APP 05

Application Number: 12/02290/FUL

Change of use from a sandwich bar (use class A1) to a hot food takeaway (use class A5) with minor alterations to shop front

AT 90 Penryn Avenue, Fishermead, Milton Keynes

PROPOSED KITCHEN EXTRACT SYSTEM

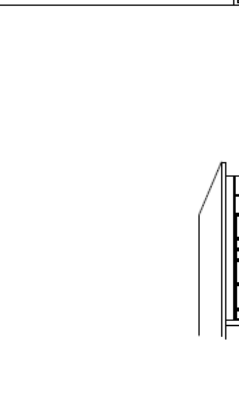
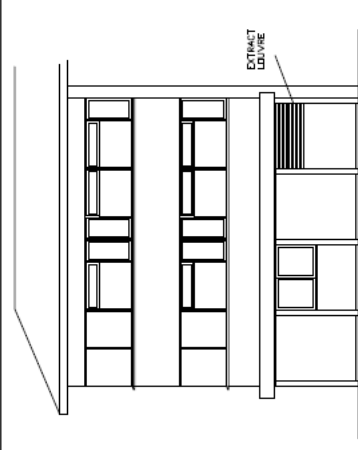
2. The details provided with regard to the kitchen extraction system shall be installed to the specification as noted in the submitted Noise Impact Assessment Report and accompanying plan DLA/CB/001 Rev. O and thereafter maintained as per the submitted details.
